THE GENERIC
SAFETY EVALUATION REPORT RELATING TO
THE MARK III CONTAINMENT HYDROGEN CONTROL

By letter dated August 24, 1987, you committed to provide, within 6 months of SER issuance, the final analysis of the Clinton Power Station combustible gas control system required by 10 CFR 50.44. Accordingly, you are requested to provide the final analysis by March 1, 1991, addressing each of the key elements identified in the staff's SER, Section 8.0.

Figure 2.1 General hydrogen igniter assembly

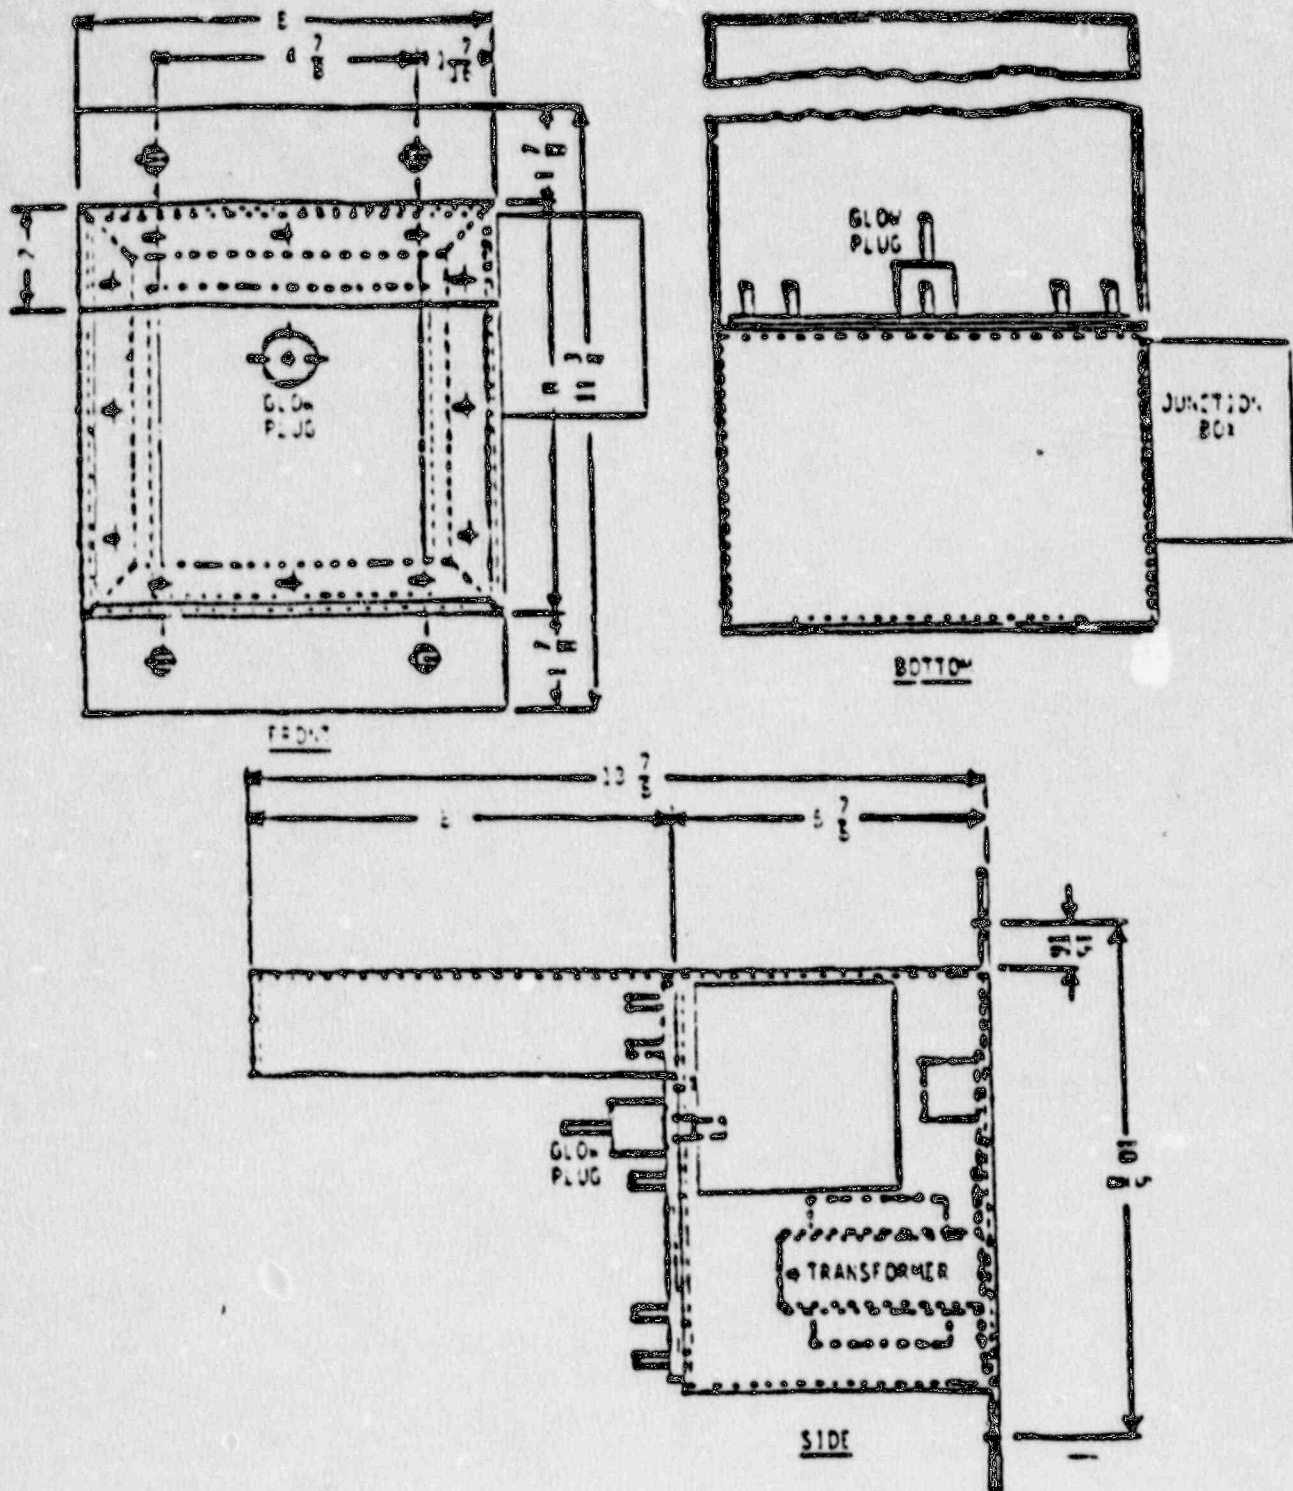
The staff finds these hydrogen igniter systems currently installed in the plants with a Mark III containment to be acceptable, with the caveat that the vulnerability to interruption of power to the hydrogen igniters be further evaluated on a plant-specific basis as part of IPEs of the Mark III plants. (See Supplement No. 3 to Generic Letter 88-20)

Figure 5.1 Hydrogen generation rate (5000 rpm reflood)

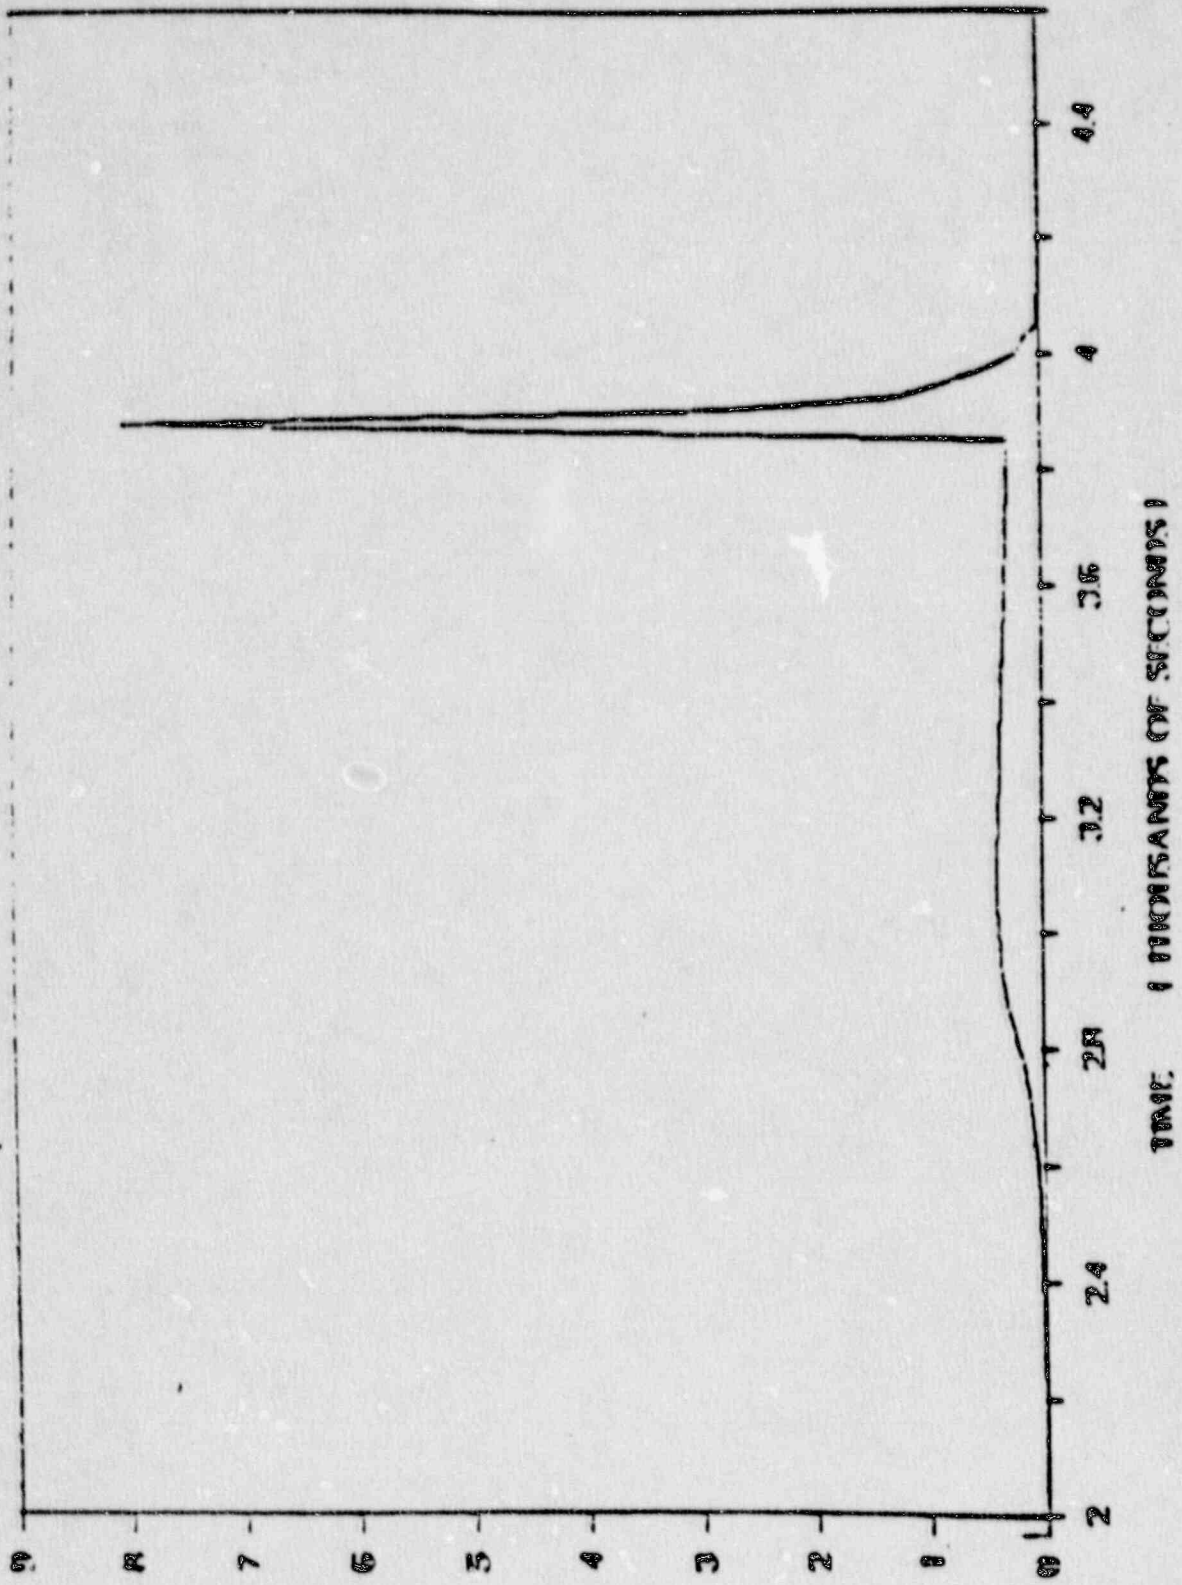
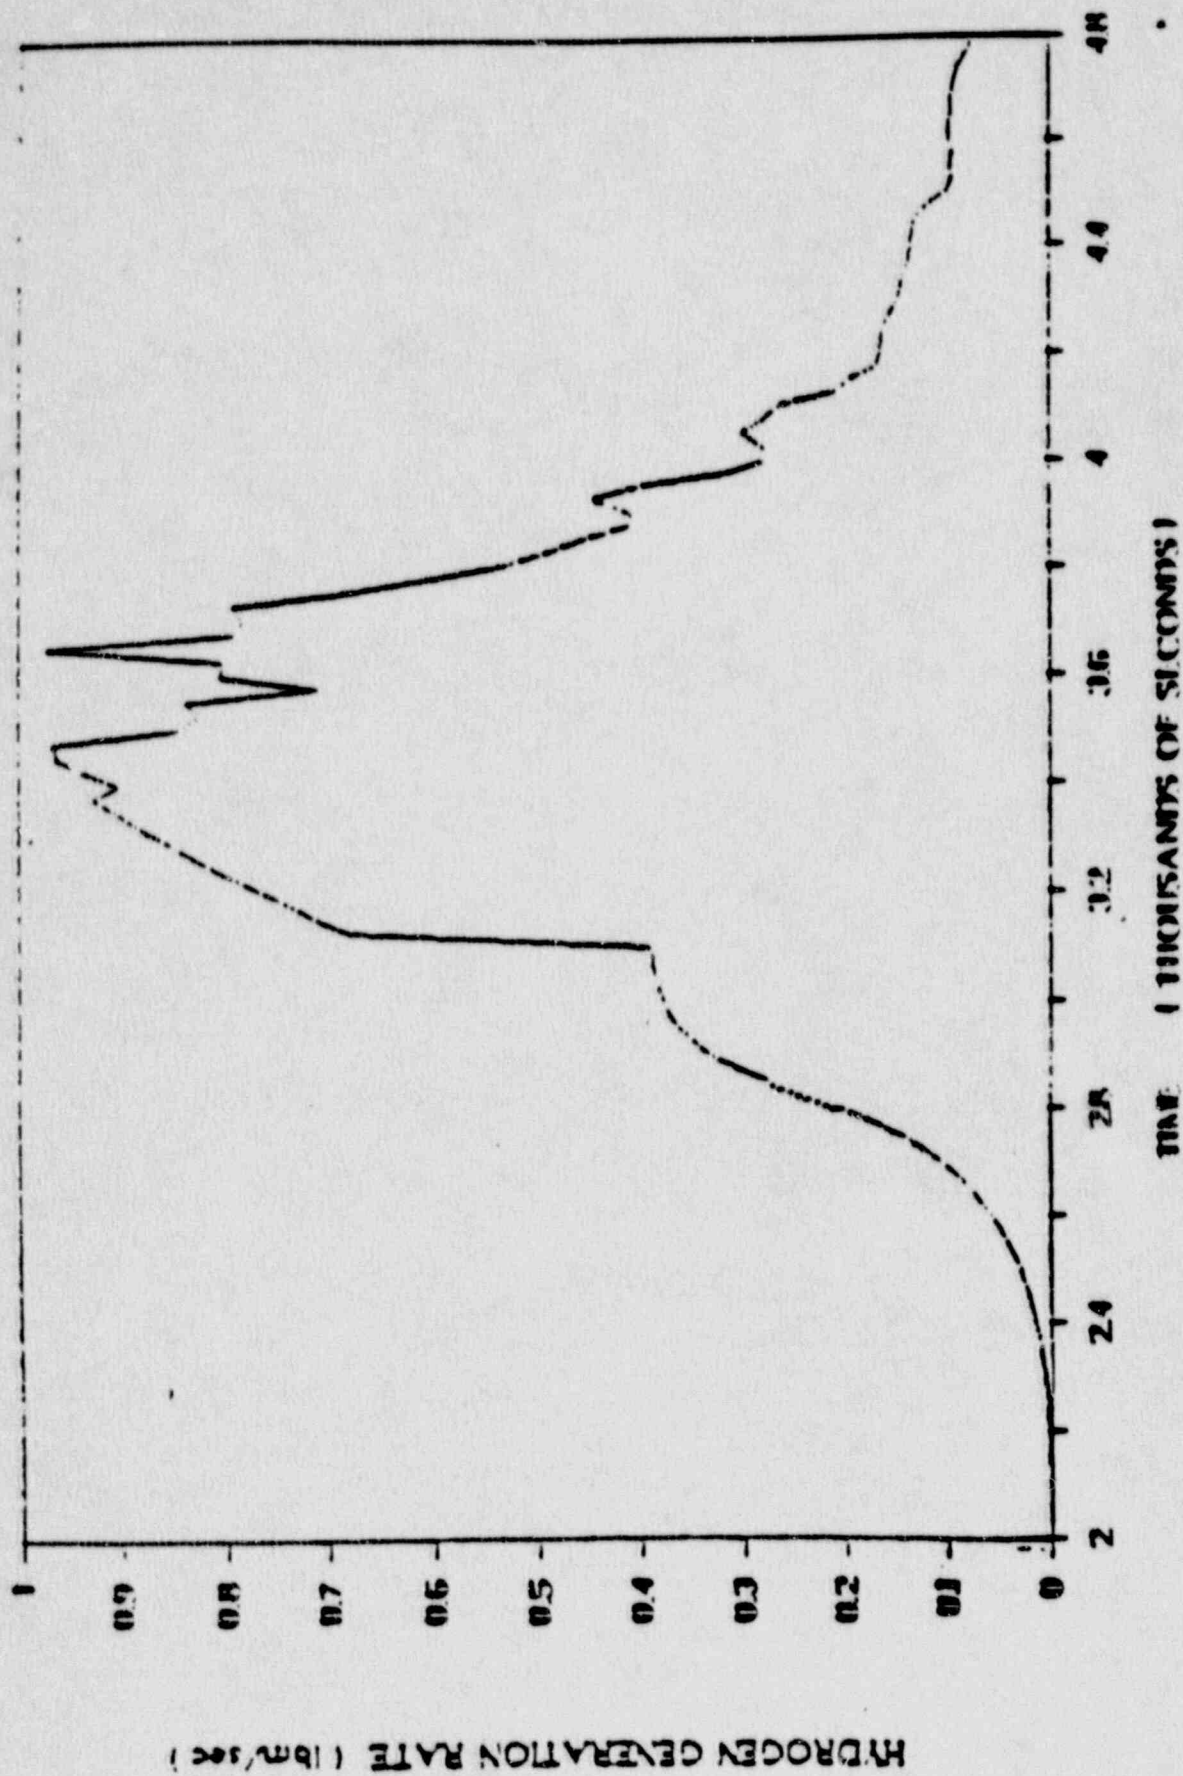
beyond the recoverability criterion and (2) the use of a non-mechanistic release model based on heat balance is reasonable and acceptable. This leads to an oxidation rate producing 0.10 lbs of hydrogen per second, requiring an extension of about 4.7 and 5.6 hours for the scenarios of Figures 5.1 and 5.2, respectively.

Figure 6.2 SORV with no spray-wetwell temperature
 Source: HGN-109-p

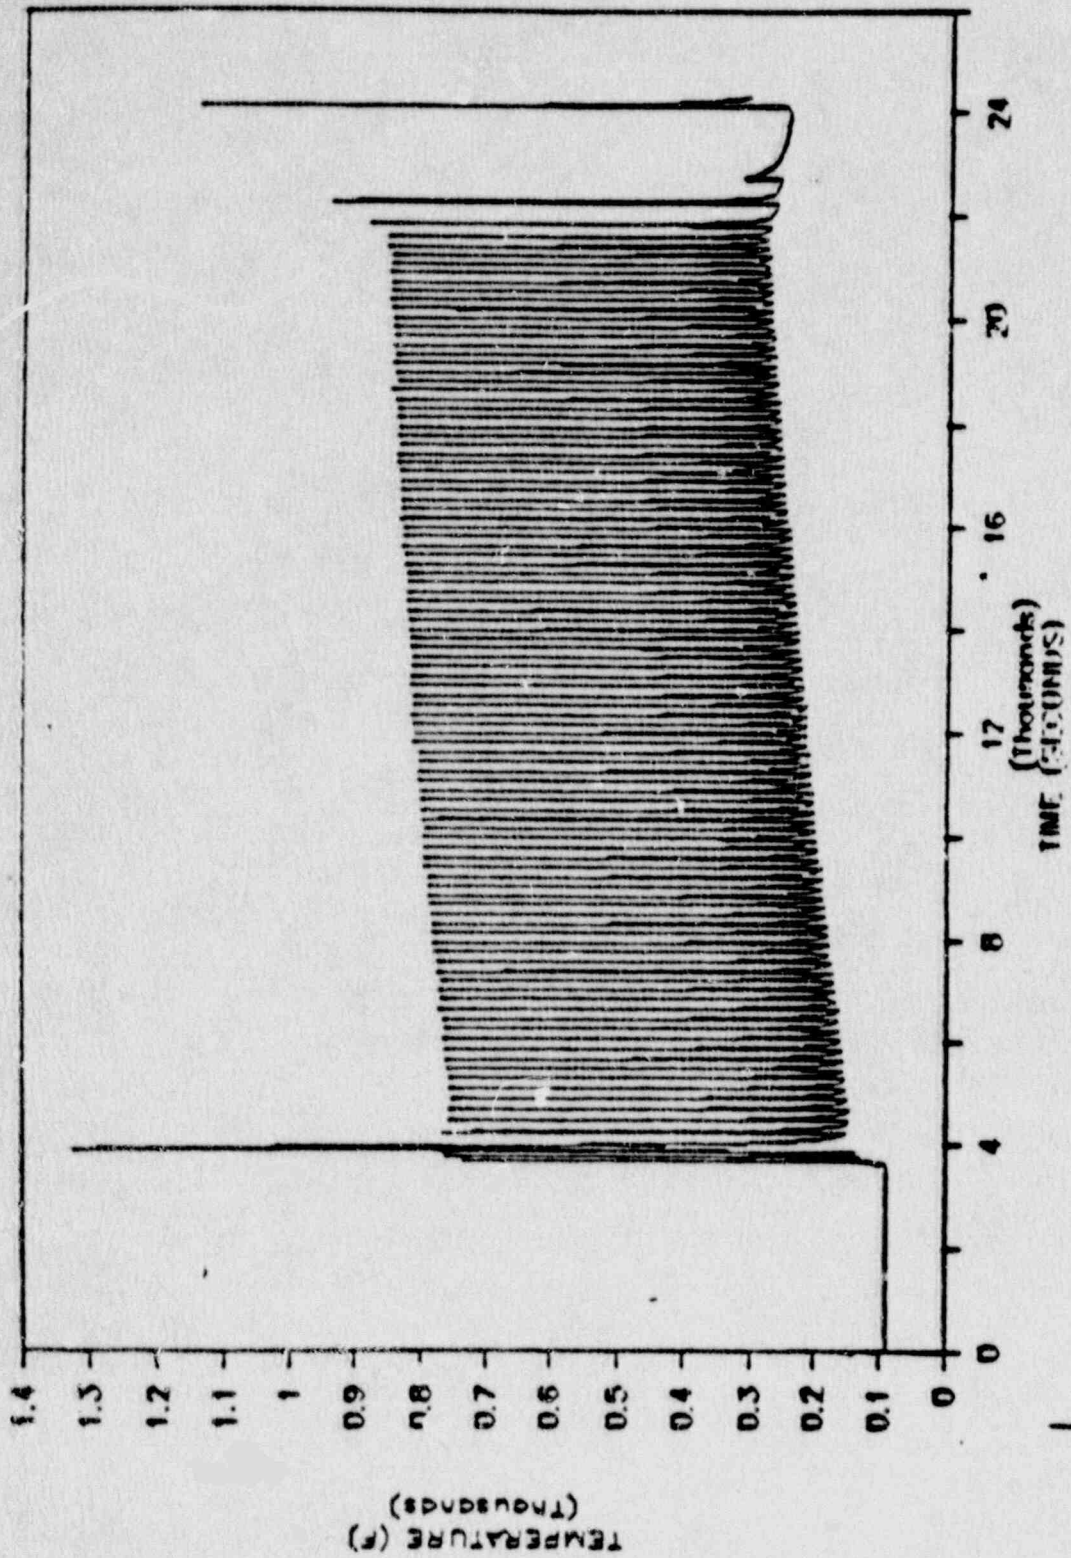
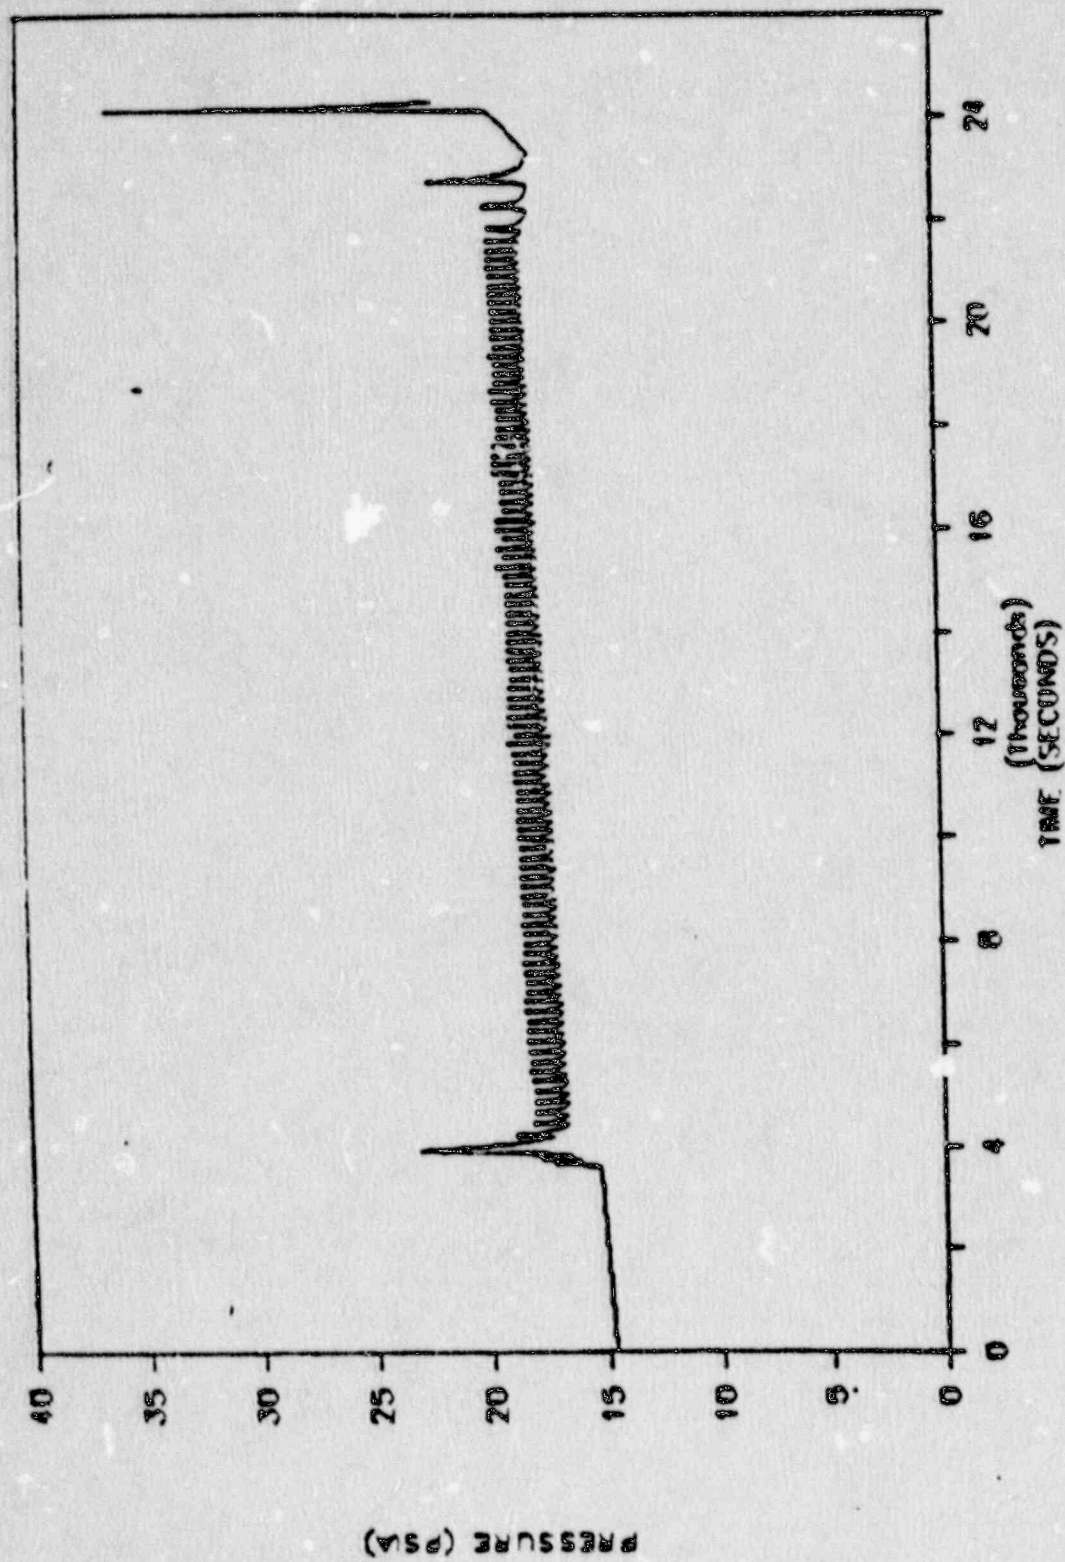
The equipment response analysis for the SORV case used the wetwell CLASIX-3 temperature profiles, presented in Section 6, with some modifications. These modified profiles exclude the few initial burns in which diffusion flames would exist and the last induced global burn. As a result, the modified wetwell profile contains about 90 serial hydrogen burns. The calculated critical component of the pressure transmitters exceeded its qualification after the seventy-first hydrogen burn. However, the HCOG indicated that the pressure transmitter is expected to survive the hydrogen event because of various conservatisms in the analysis.

The staff acknowledges conservatisms, as discussed earlier, are contained in these analyses which could compensate for the temperature exceedance over the qualification of the pressure transmitter. Nonetheless, the staff requested the HCOG to provide additional data on the qualification of the pressure transmitter. By letter dated April 5, 1988 (HGN-131-P), the HCOG indicated that during qualification testing the transmitter had operated without failure at surface temperatures approaching 380°F for several minutes (as compared to the qualification of 320°F). As part of the HCOG's response, an equipment response analysis of the pressure transmitter was re-evaluated assuming containment sprays to be available. This response analysis indicated that the equipment surface temperature was about 70°F less than qualification temperature of 320°F. These results
